Remarks

Keith Frantz, Reg. No. 37828
401 West State Street, Suite 200
Rockford, Illinois 61101
(815) 987-9820
(815) 961-1583 [fax]
Serial No. 09/490,370
Filing Date: January 24, 2000

Mark-up of
original FIG. 1

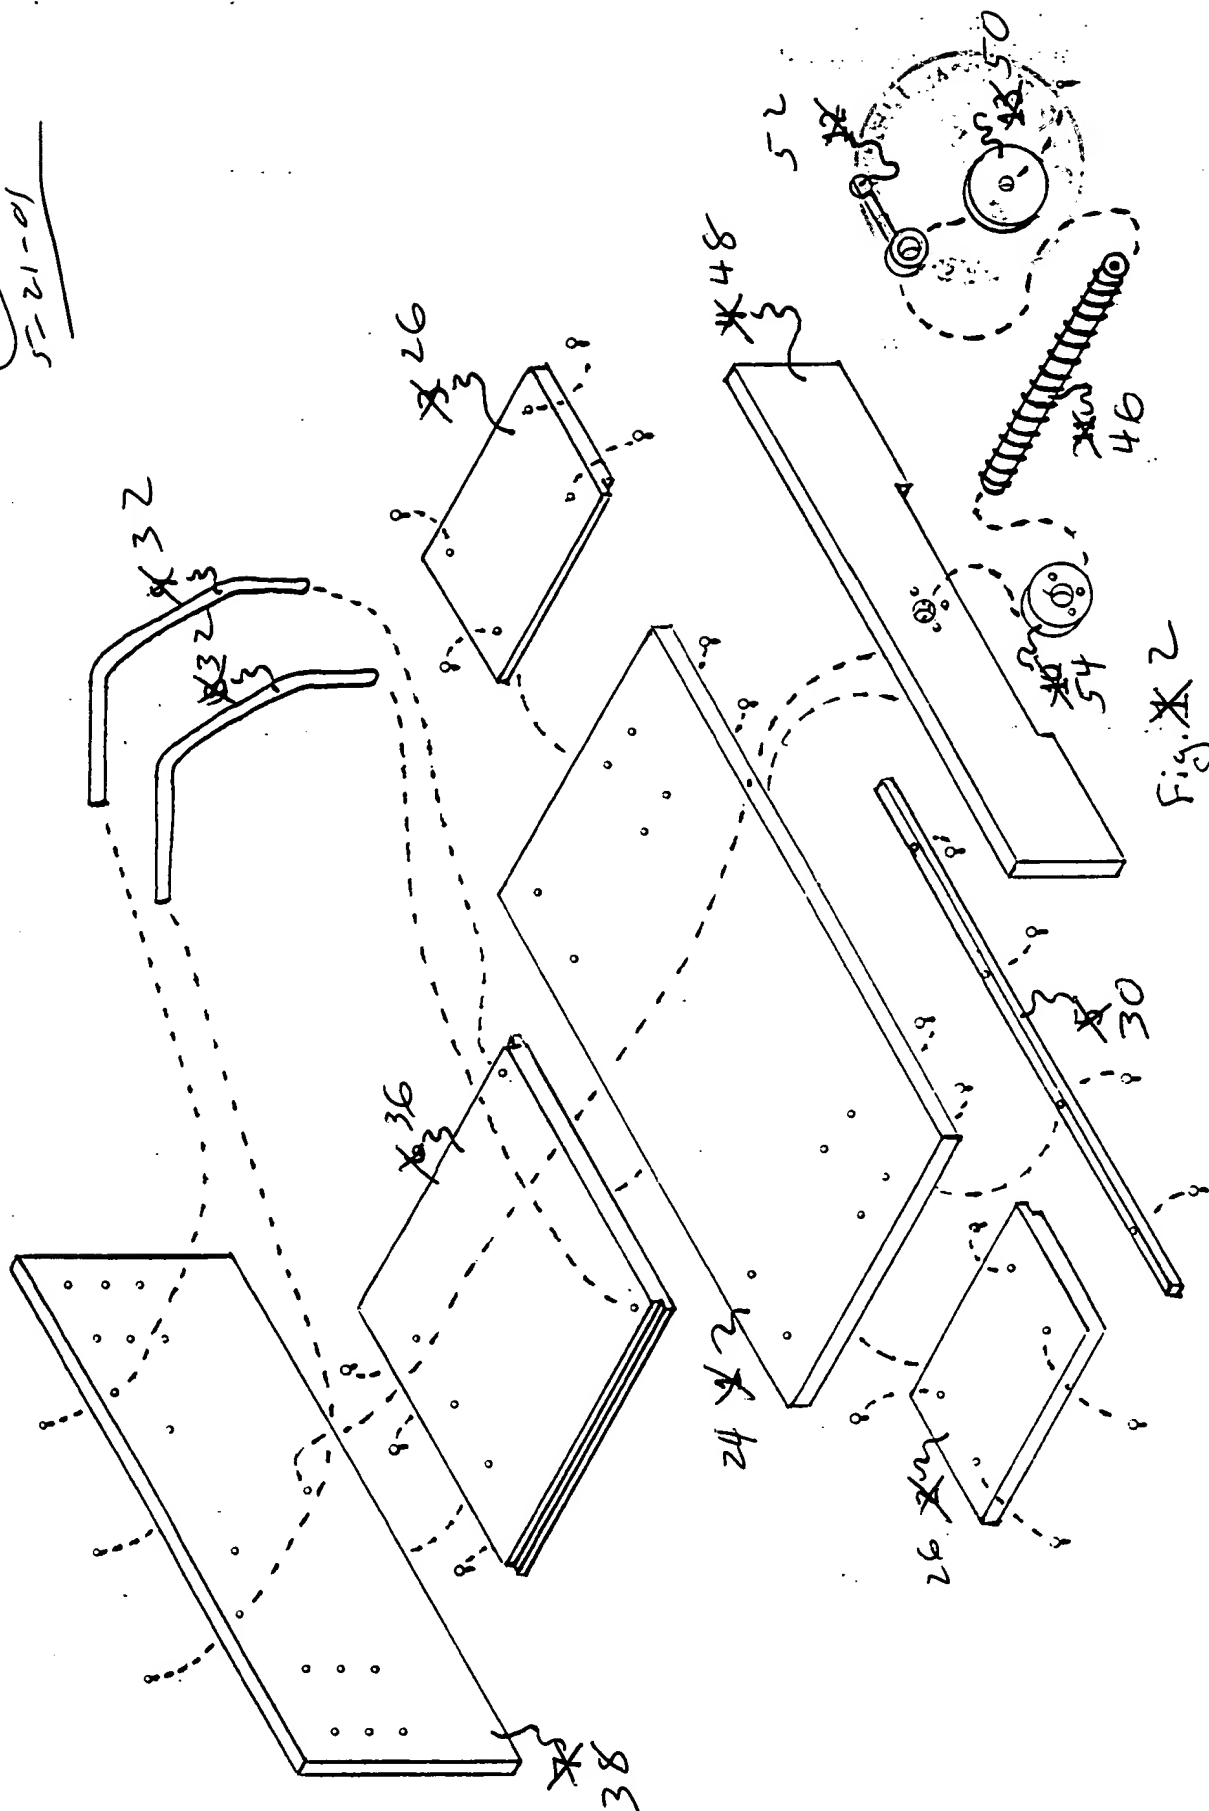
The original drawing was objected to by the examiner.

For the examiner's convenience, a copy the original drawing marked-up with blue ink is attached hereto, with the reference numerals of the original specification "X-ed" out and the corresponding reference numerals of the substitute specification written adjacent thereto.

The substitute drawings are presented to better comply with statutory requirements and format guidelines. It is believed the substitute drawings are fully supported by the original specification and drawings, and do not include new matter.

The substitute specification more clearly identifies the elements originally numbered 10, 11, 12, and 13 in the original specification as:

Number in Original Specification	Number in Substitute Specification	Description
10	54	mounting nut
11	46	threaded drive screw
12	52	lock nut
13	50	handle
